Subject: **Request for Modification of Section 404 General Permit No. 198200031 and Section 401 Water Quality Certification, and lifting of Notice of Violation Status** for the Interstate 85 (I-85) widening and interchange improvements from north of NC 73 to north of SR 1280, Cabarrus and Rowan Counties, Divisions 9 and 10. Federal Aid Project No. NHIMF-085-2(61)55, TIP I-3802A.

The North Carolina Department of Transportation (NCDOT) requests modification to the existing General Permit No. 198200031 and associated Water Quality Certification for widening and interchange improvements along I-85 in Cabarrus and Rowan Counties. This project is currently under construction.

Revisions have been made to seventeen impact sites and are discussed in detail below. Two new impact sites are also discussed below (Site 36 and the Troutman waste site).

REVISIONS

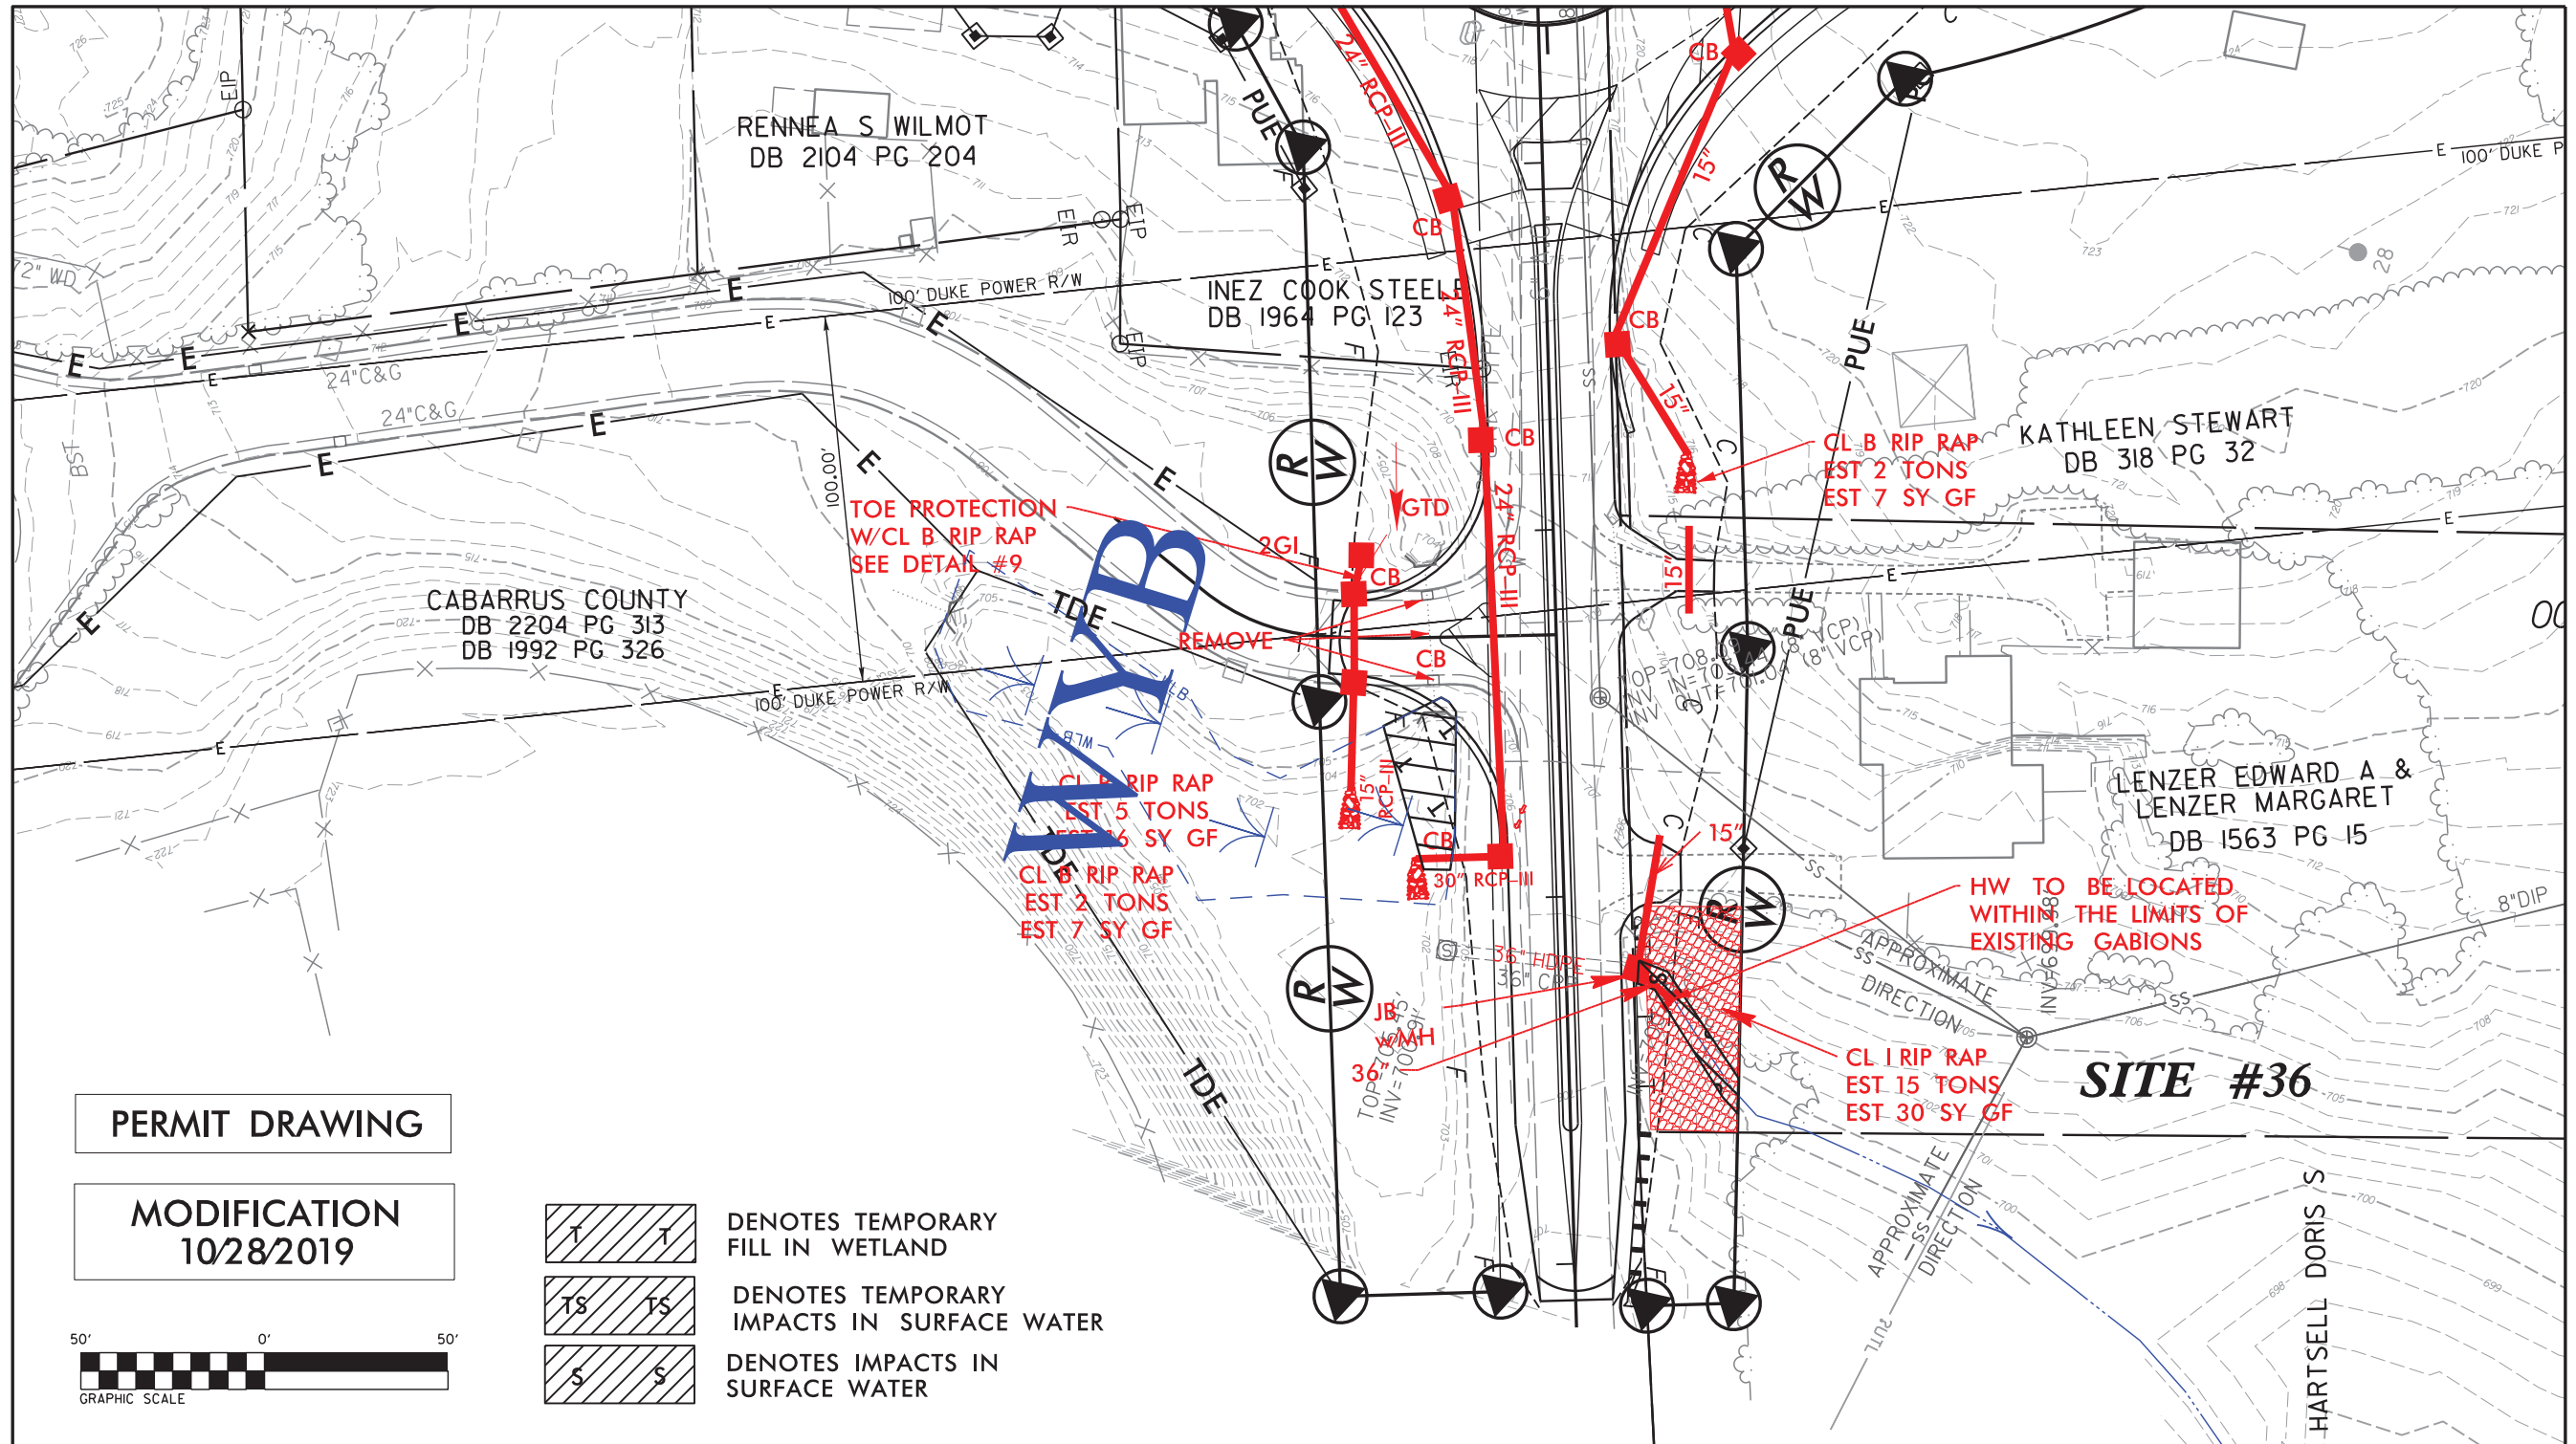
Site 36 (Sheet 34) –This site has been added to account for impacts resulting from the extension of an existing 36” pipe and installation of Class I rip rap in the stream bed at the pipe outlet. The pipe is located at the edge of the study limits and the stream was not identified in the original Jurisdictional Determination (JD). Permanent stream impacts increased from 0 linear feet to 61 linear feet. Also, a temporary sediment basin was added inadvertently in wetland WYB at the upstream end of the existing pipe crossing, resulting in 0.01 acre of temporary fill wetland impacts.
